Docket Item #4
BAR CASE #2005-0232

BAR Meeting
November 2, 2005

ISSUE: Addition and alterations

LOCATION: 715 South Lee Street

Figure 1 Proposed south elevation

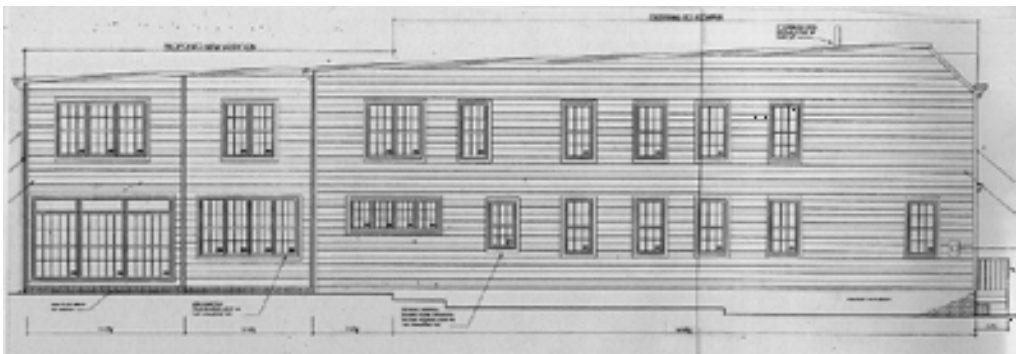
The infill addition at the southwest corner of the historic main block appears as an extension of the historic main block. According to the *Design Guidelines*, “an addition to a historic building should be clearly distinguishable from the original structure.” (Residential Additions - Page 5). Optimally, Staff would like to see any addition here be pulled in from the south side elevation so that the full extent of the historic building can be “read” and understood. However, at the very least, Staff believes the addition should be designed so that it is readily viewed as a separate and new piece. One step toward this goal would be to leave all the fenestration on the historic main block as it is and begin the new ganged fenestration pattern on the new construction. Of course, this would, require alterations to the interior plan.

In addition Staff is concerned about the appearance of the fire-rated windows. The fixed steel windows will not have the same appearance as double-hung wood windows and are not typical of or compatible with 19th century residential construction. The juxtaposition of the two types on the south elevation will be odd. Staff does not object to their use on the areas of modern construction, but would prefer to see them eliminated from the historic main block. Staff is particularly concerned by the proposed new window at the front of the south elevation. This window will be readily viewed from the public right-of-way. While the plans do not indicate that it will be fire-rated, Staff’s understanding of code requirements suggests that it must be.

- F-1 The existing dwelling has numerous windows along the South face of the structure at the 0 lot line. The proposed plans indicate replacement and addition of windows along this wall. Replacement in kind, without modifications to the existing openings will be permitted. Additional windows or enlargement of existing openings along this wall is prohibited. Furthermore, Code Enforcement recommends the removal of all windows along the South face due to the location of the windows in relation to the interior lot line.

- C-1 All exterior walls within 5 feet from an interior property line shall have a fire resistance rating of 1 hour, from both sides of the wall. As alternative, a 2 hour fire wall may be provided. This condition is also applicable to skylights within setback distance. Openings in exterior walls between 3 and 5 feet shall not exceed 25% of the area of the entire wall surface (This shall include bay windows). Openings shall not be permitted in exterior walls within 3 feet of an interior lot line.

1. That there be no fire-rated windows installed on the front or south side elevations of the historic main block;
2. That any replacement windows on the historic main block be wood, true-divided-light windows with a two-over-two configuration;
3. That the shutters be hinged and operable;
4. That the front cornice be retained;
5. That the front mansard roof be either true slate or metal shingles, to be approved by Staff;
6. That the wood siding on the historic main block be either repaired and retained or replaced with wood German siding to match the original; and,
7. That the fiber cement siding be used only on the new additions and 1978 addition and that it be smooth and installed so that the nails do not show.

Figure 2 Proposed west elevation

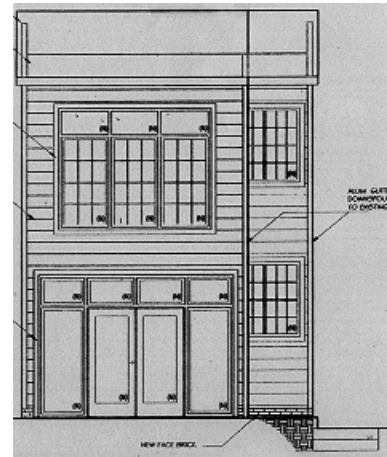
The rear (west) elevation of this addition will have a pair of full-light french doors flanked by fixed full light windows and surmounted by transoms on the first floor. The second story will have a ganged set of three 12-light windows with full-light transoms above. The notes on the drawing indicate that the windows and doors on the rear elevation are shown will be true-divided light with 7/8" muntins. The applicant has provided a cut sheet for Marvin wood windows. The drawings indicate that this elevation will be clad in painted 8.5" wood siding. The drawings do not include the north elevation of the new addition. It is assumed that it is blind and clad in Hardiplank. The flat roof of the new addition will be a single-ply membrane roof. There will be an aluminum gutter across the rear and a downspout at the southwest corner.
